**Statement of Response to DCC's LRD Opinion
under Reg Ref.: LRD6009/22-S2**

**St. Vincent's Hospital Fairview Redevelopment
LRD Planning Application**

**St. Vincent's Hospital, Richmond Road and
Convent Avenue, Fairview, Dublin 3**

John Spain Associates

Figure 2.1: Masterplan for the overall Z12 and Z15 Zoned Lands

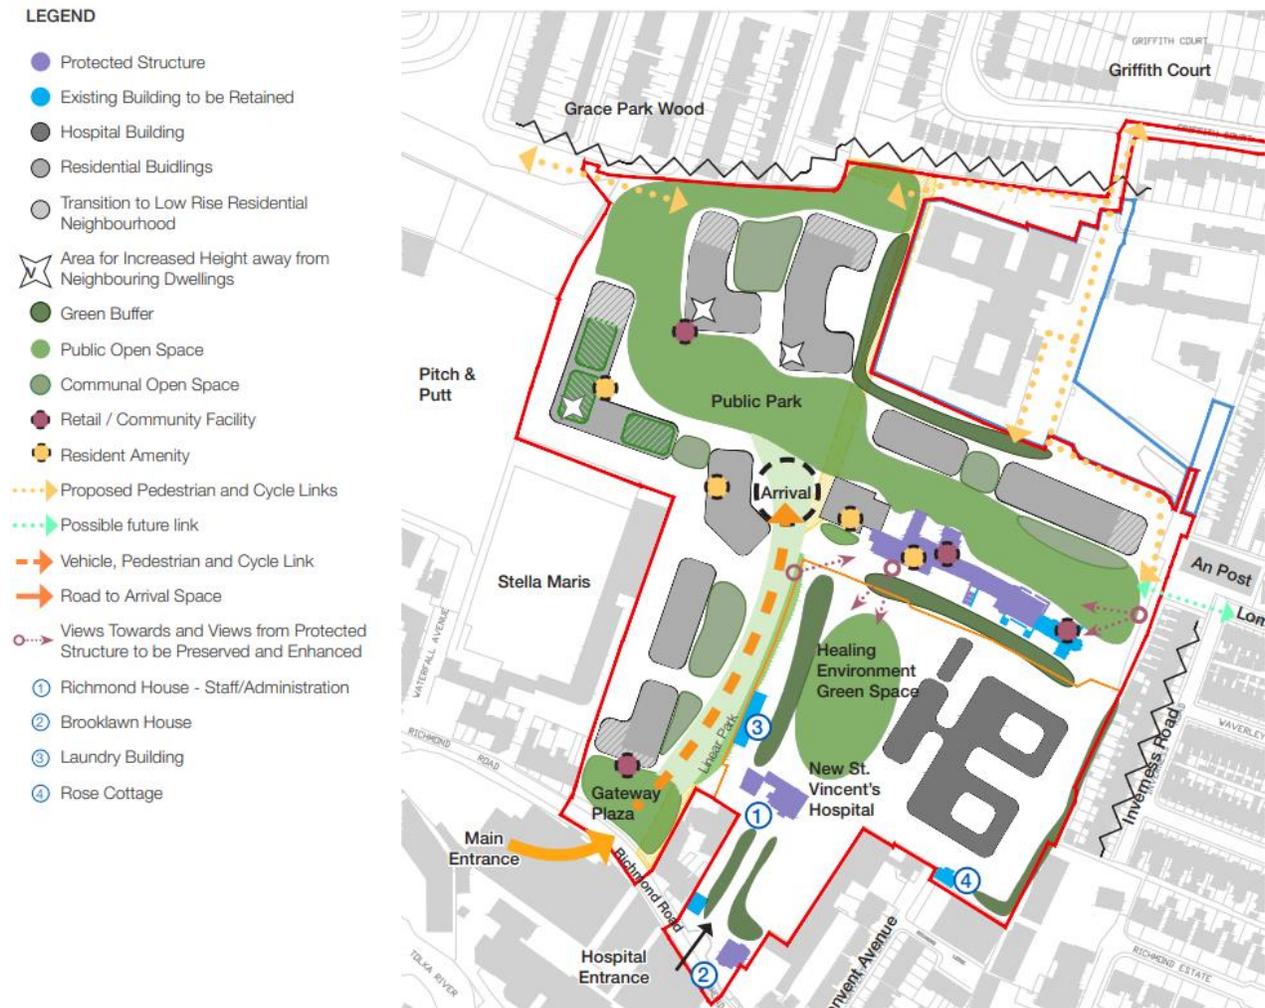
“The application will be determined under the incoming Dublin City Development Plan 2022-2028. The applicant is requested to further outline how the development will comply with the new requirements set out for zoning objective Z15 Community and Social Infrastructure and in particular, the applicant will need to adequately justify how the proposed residential and commercial development on the Z15 lands is subordinate in scale to St Vincent’s Hospital.”

- A Z12 / Z15 Masterplan has been prepared for the overall landholding, and accompanies this application, and provides a vision for the future and long-term use of these lands, which the subject application seeks to deliver upon. The masterplan demonstrates how the primary institutional / community use, i.e. the hospital, will be protected and facilitated into the future, with new residential apartment buildings and generous new public open spaces, primarily on the Z12 zoned portion of the lands, and facilitating permeability through the site and connections to surrounding neighbourhoods.

Thus, the institutional use of the Z15 lands at St. Vincent's Hospital Fairview will remain as the primary use on the Z15 zoned portion of the land, with the residential and commercial uses being ancillary elements and therefore the principle of the development is considered to be acceptable and consistent with the zoning objective. The following section of this response addresses the other specific aspect of Item 1 of the Opinion.

Figure 2.4: Illustration of the Proposed Connections to Grace Park Wood and Griffith Court

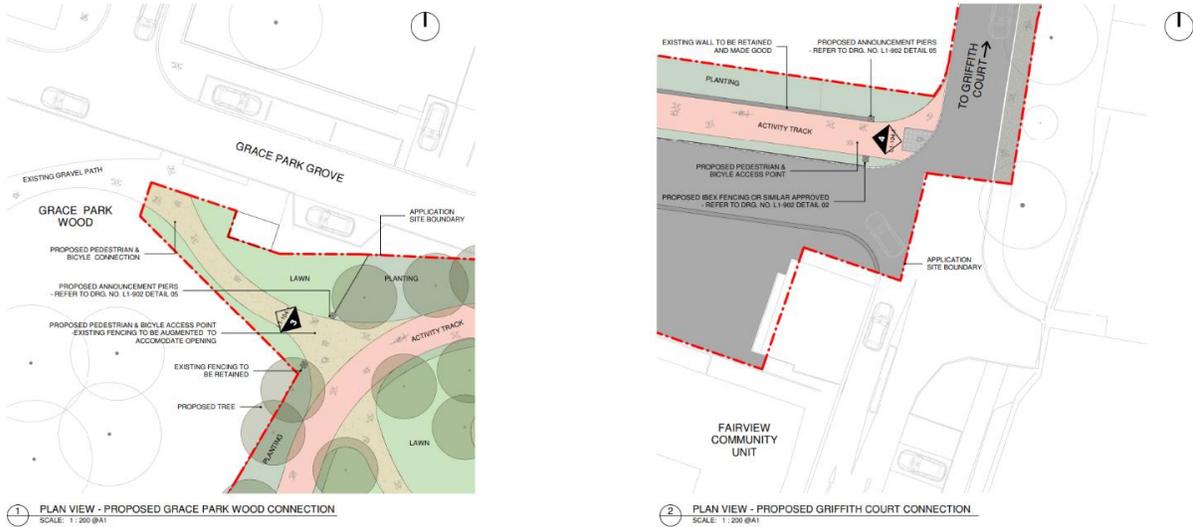
- a) ***In order to justify the heights and densities proposed and to demonstrate that the proposed 'central park' will function as a public open space, it will be critical to demonstrate that the pedestrian routes and connectivity through the site will be delivered as part of the proposed development. In order to ensure the Planning Authority's support of the scheme in this regard, the application shall be***

In response to Item 3(a) of the LRD Opinion, the application includes a proposed pedestrian / cycle connection to Griffith Court, requiring alterations to the service yard of the Fairview Community Unit, two pedestrian / cycle connections to the Fairview Community Unit campus to the north (providing an onward connection to Griffith Court and Phillipsburg Avenue), and a pedestrian / cycle connection to Grace Park Wood, within the red line application site boundary. NMP drawings 104-1 and 104-2 (see extracts below) provides details of the proposed connections.

Figure 2.9: Detailed Diagram with Block B and A

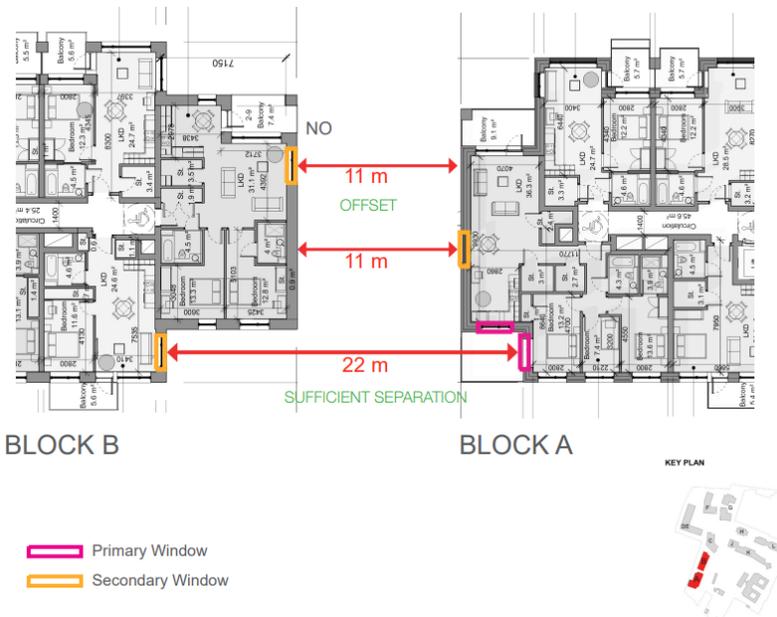
- c) ***Provide a report which sets out measures to maximise future occupants' private amenity by minimising reciprocal potential overlooking between unit's balconies and window where the blocks' elevations are in close proximity to each other – such as considering applying: high screens to the sides of projecting balconies; directional overlooking treatments; opaque glazing to balconies, opaque glazing and/high level windows to unit's secondary opes (while still allowing sufficient access to daylight to best practice recommendations); mismatching directly opposing opes (hit & miss) where active windows are at close quarters with each other.***

We refer to STW's Architectural Response to DCC's LRD Opinion which demonstrates measures to maximise future occupants' private amenity by minimising reciprocal potential overlooking between unit's balconies and windows where the blocks' elevations are in close proximity to each other. High screens are also proposed to the sides of opposing balconies to avoid directional overlooking.

The STW report provides examples of opposing residential blocks and the design measures provided to reduce overlooking. STW indicate secondary windows facing primary windows across a reduced separation distance, which are smaller in scale, offset and the secondary window glazing is frosted for assurance of privacy for both units.
